File Number: 9-C-25-IH

Location: 225 E. Oldham Ave. **Parcel ID:** 81 K H 020
Zoning: RN-2 (Single-Family Residential Neighborhood)
Description: After-the-fact revisions to 11-H-24-IH

After-the-fact revisions to COA 11-H-24-IH. Revisions include:

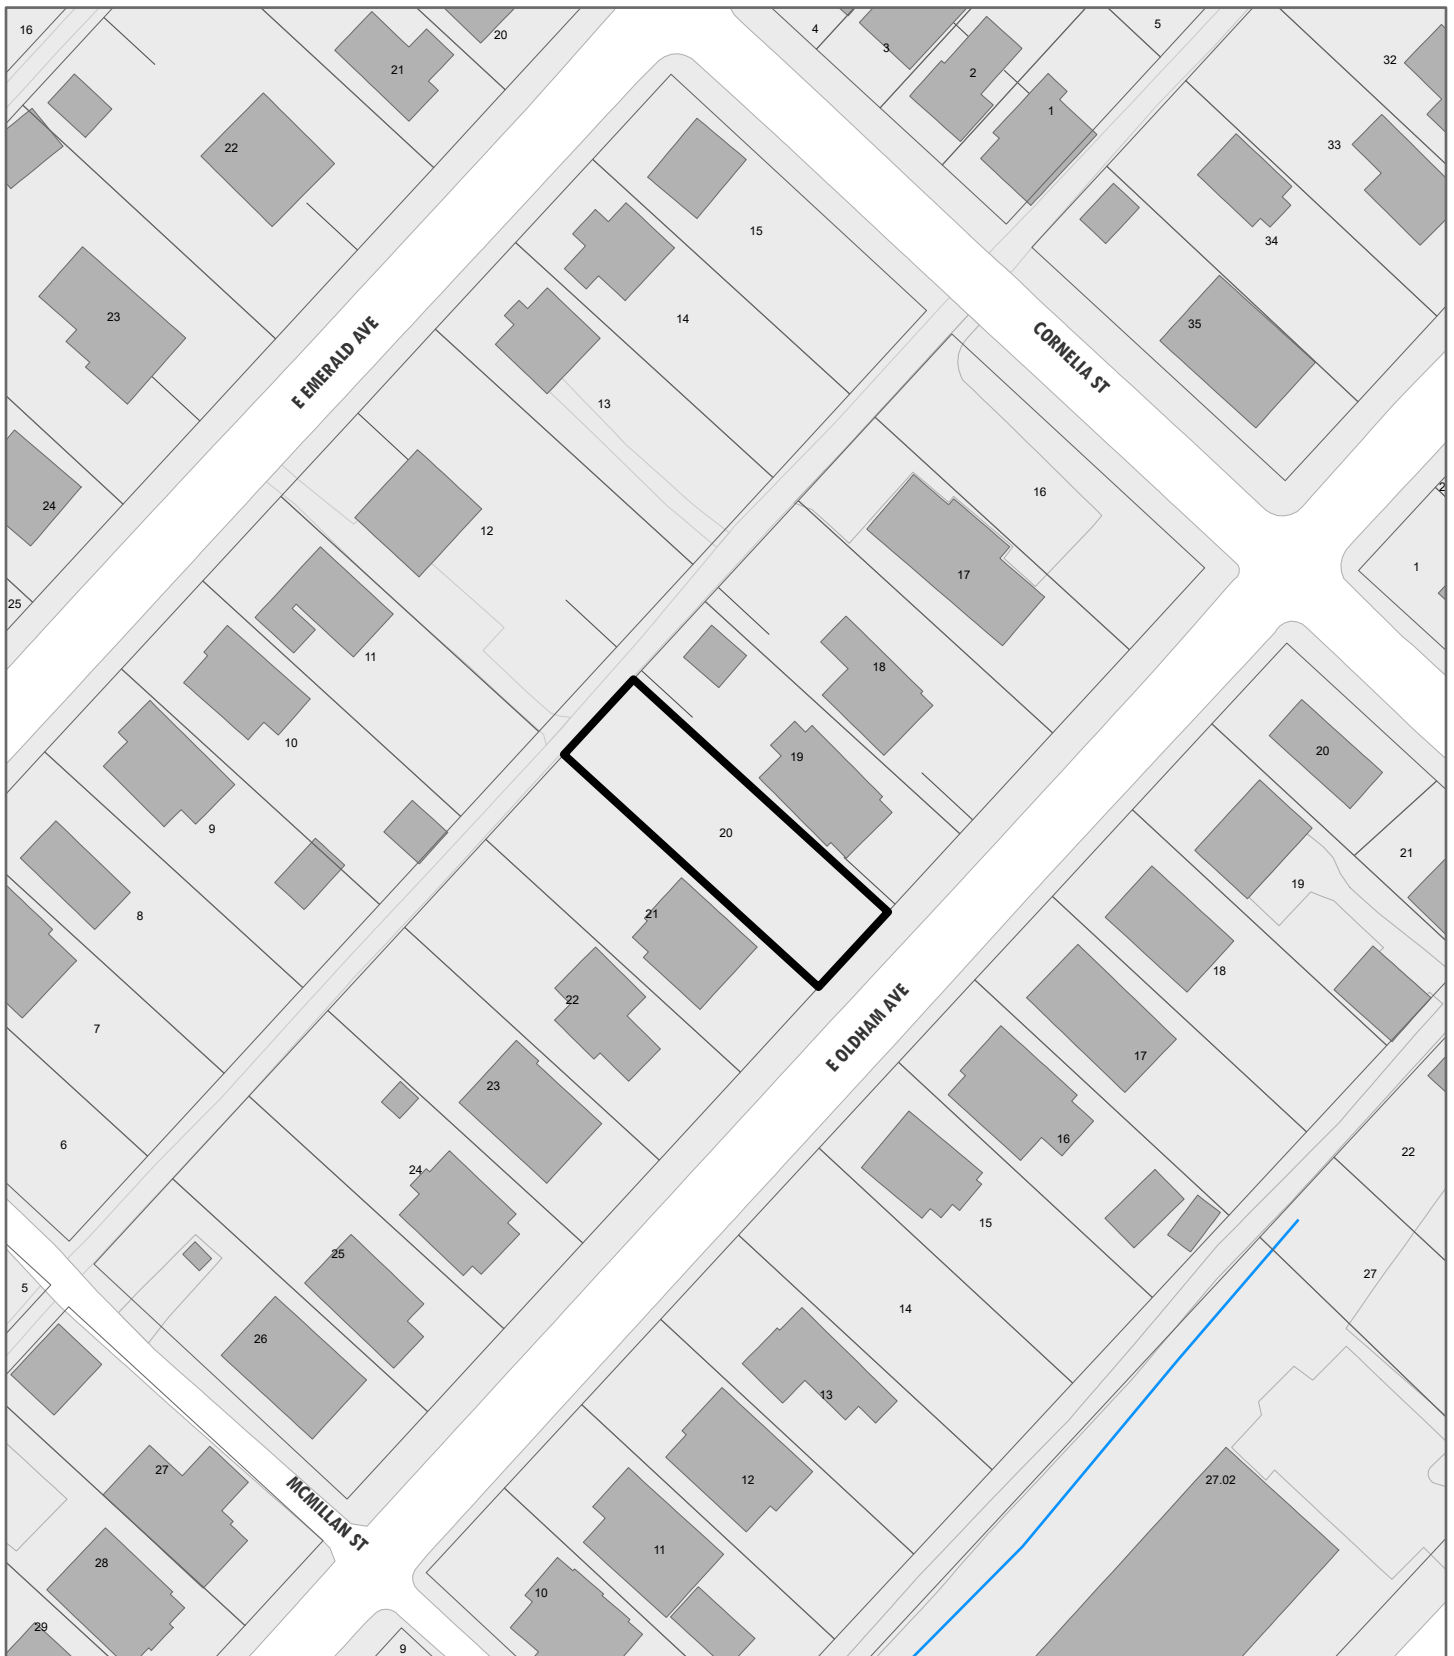
5. The design guidelines state that “porch posts and railings should be like those used in the historic era of the neighborhood’s development” and that “porches should be proportional to original porches on the block.” The guidelines for multi-unit housing emphasize that buildings “be designed in scale and context with the early architectural features of the neighborhood.” The height, form, and detail of the constructed front porches is incompatible with the historic houses on the block and significantly increases the visual scale of the structure.

Revised Site Plan

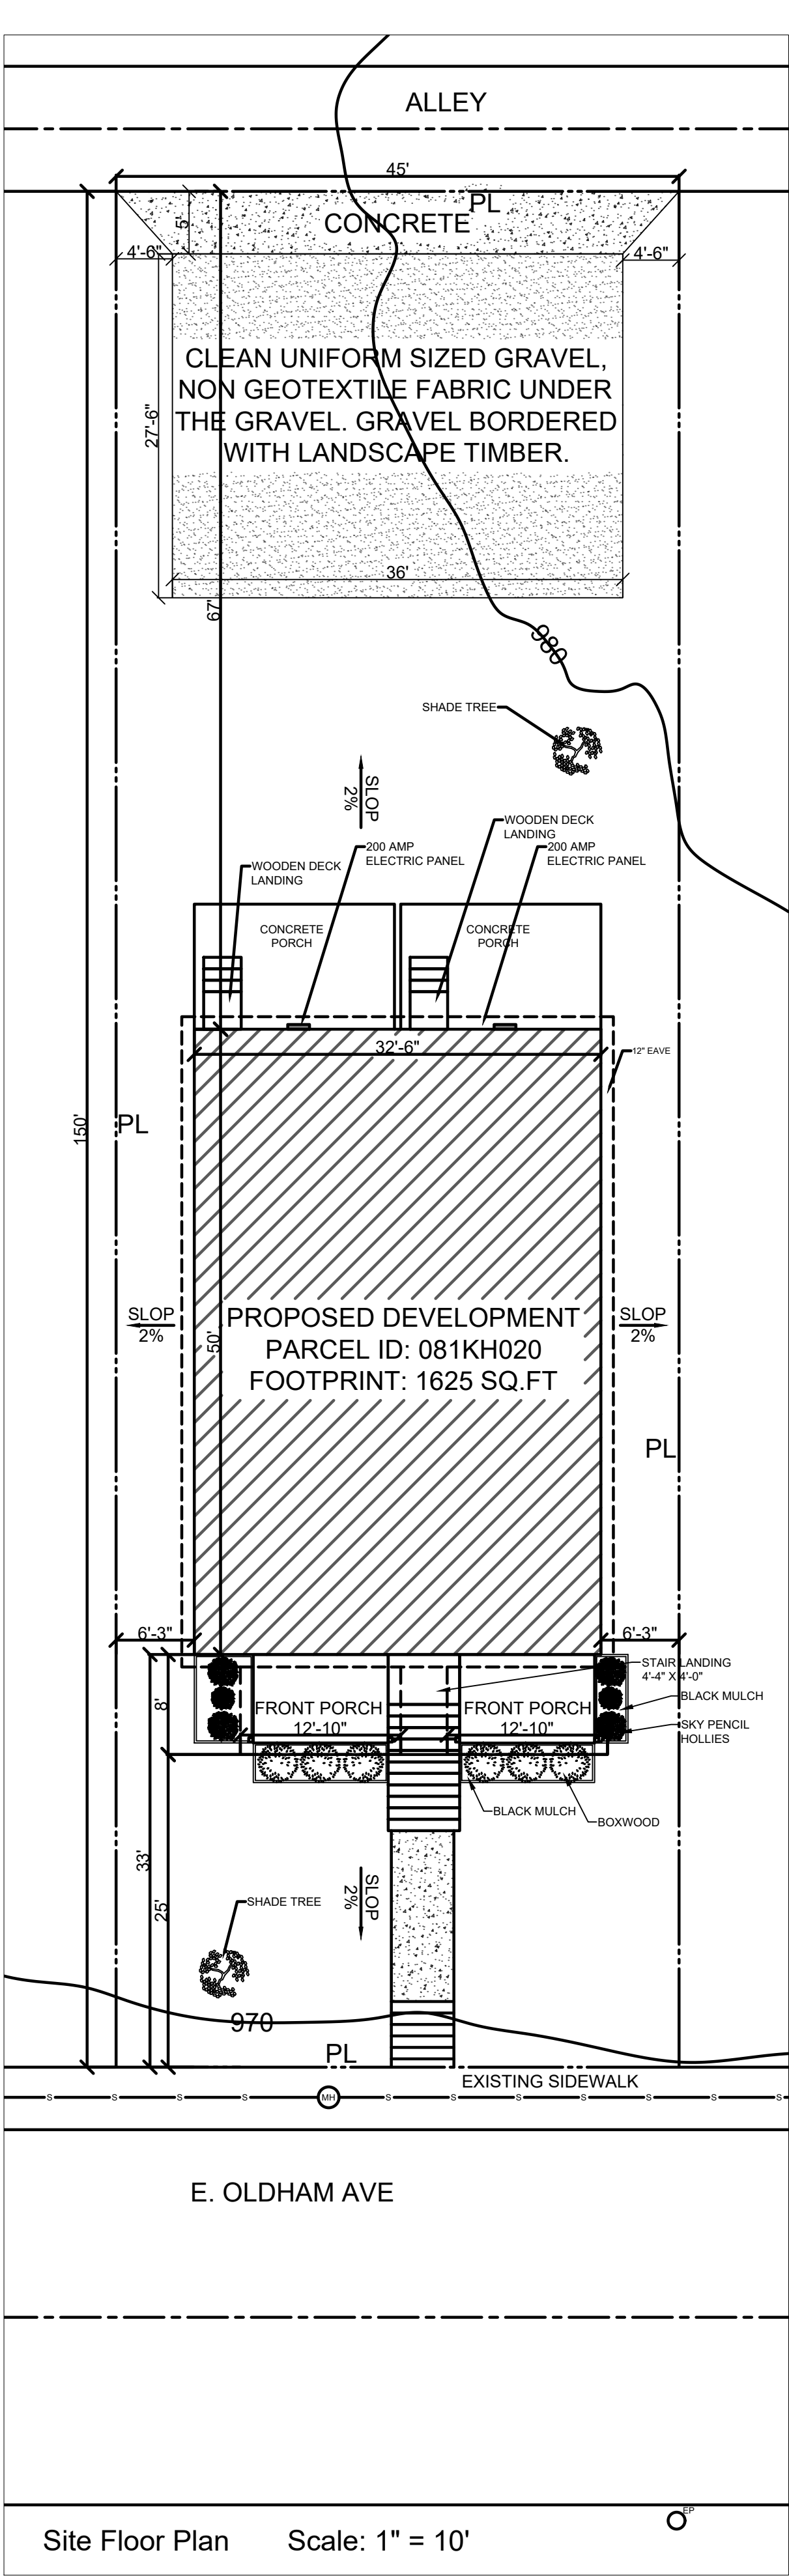
2. This is a Middle Housing project, and the approved plans did not include parking, as it is not required under Article 4.6.D. The applicant coordinated with City Engineering to determine the minimum size for four parking spaces, as requested by the Board, and has revised the parking size accordingly from the previous submission. The proposed 36' wide by 32'-6" deep gravel parking pad at the rear of the lot accessed via the alley meets the Infill

6. The proposed central staircase massing reflects the form of historic houses on the block and within the neighborhood with raised foundations to account for grade and is smaller in scale than what was constructed. Alternative staircase options are limited due to the height of the building and the shallow depth of the front yard. The lattice screening is more compatible with the building and other houses on the block than the installed wood decking, and it benefits from the screening of the planter boxes. The addition of newel caps on the staircase contributes architectural detail that reflects the historic context. These revisions meet the design guidelines and are informed by the context.

7. The proposed planter boxes screen the height of the porches and foundation, and they introduce a horizontal break that minimizes the visual scale. They also reflect other efforts to mitigate the effect of tall foundation heights in the neighborhood through the use of masonry, such as planter boxes and brick wing walls. In the opinion of staff, any of the proposed materials for the planter boxes can be appropriate, although landscaping/gravity blocks would be less preferable due to the exposed concrete. The design guidelines recommend that native or naturalized shade trees be used, so the sky pencil holly (*Ilex crenata*), which is classified as invasive by the Tennessee Invasive Plants Council, is not an appropriate option. Boxwood is a native species, and green giant arborvitae is neither native nor invasive. These options are appropriate, as are other native or naturalized shrubs. Final landscaping selections should be approved by staff.
